Subject: VIRGIL C. SUMMER NUCLEAR STATION (VCSNS) UNIT 1
DOCKET NO. 50-395
OPERATING LICENSE NO. NPF-12
SOUTH CAROLINA ELECTRIC & GAS (SCE&G) RESPONSE TO NRC
REQUEST FOR ADDITIONAL INFORMATION ASSOCIATED WITH NEAR-
TERM TASK FORCE RECOMMENDATION 2.1, FLOODING REEVALUATION

SCE&G Response to Request for Additional Information

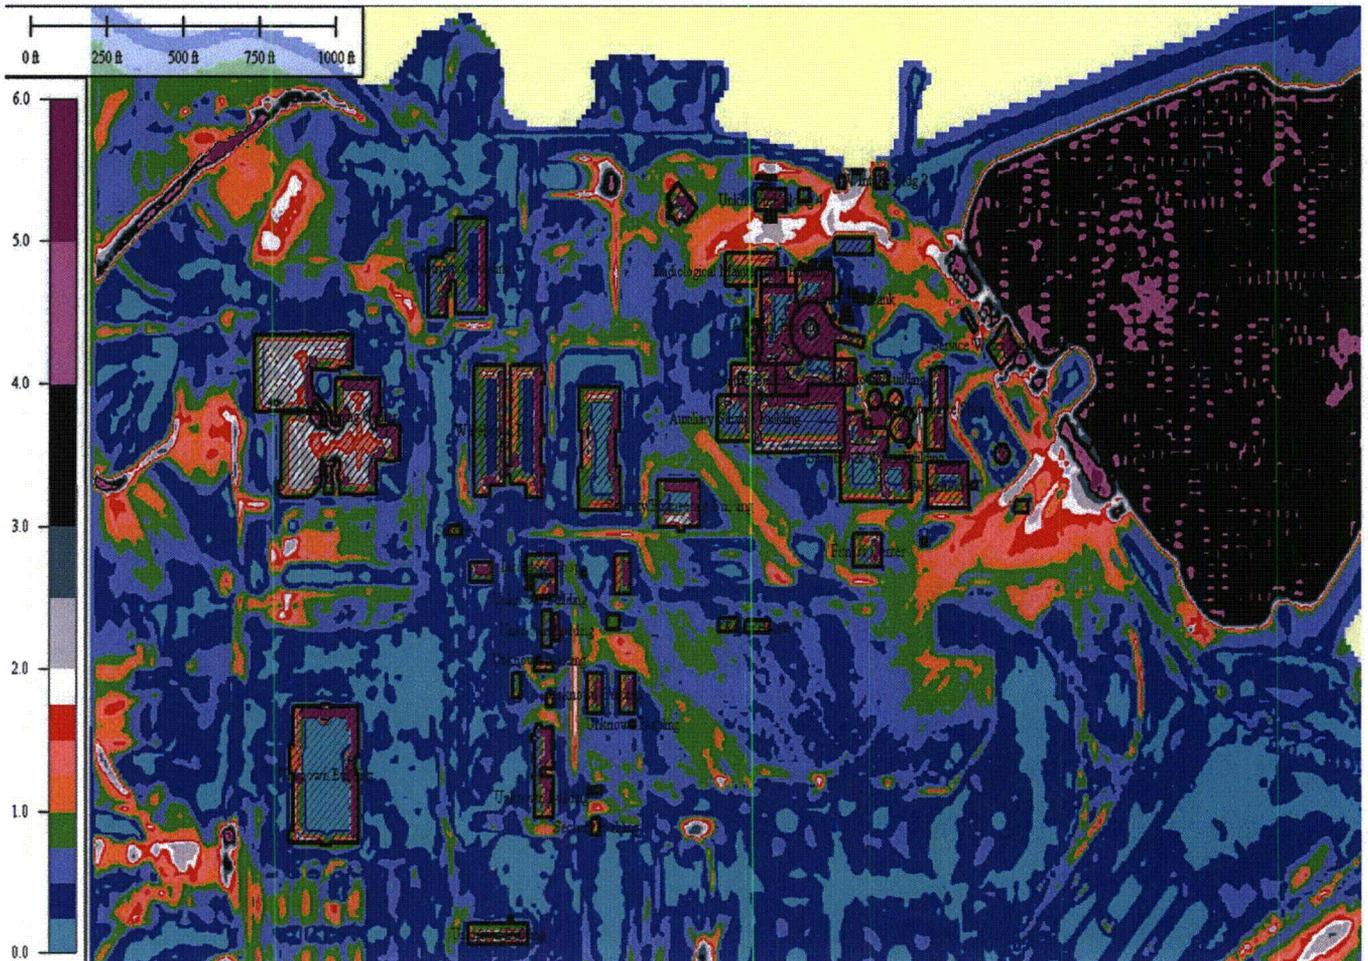
Request: The licensee is requested to provide the flood height and associated effects (as defined in Section 9 of JLD-ISG-2012-05) that are not described in the flood hazard reevaluation report for mechanisms that trigger an Integrated Assessment. This includes the following quantified information for each mechanism (as applicable):

- **Debris impacts,**
- **Effects caused by sediment deposition and erosion (e.g., flow velocities, scour),**
- **Concurrent site conditions, including adverse weather, and**
- **Groundwater ingress**

Maximum flow velocities were reviewed and found to be less than 2 fps for about 97% of the yard areas. The only areas where velocities exceed 2 fps are in portions of the flow path north of the power block and at the southeast of the main plant just before the runoff enters the SWP. Velocities are higher where the runoff flows down the west embankment slope. That slope is protected by riprap. See attached figure, velocity color legend on left.

Notes: Velocity (ft/sec) is shown in the color legend on left
High velocities on or near buildings represent flow off the buildings.
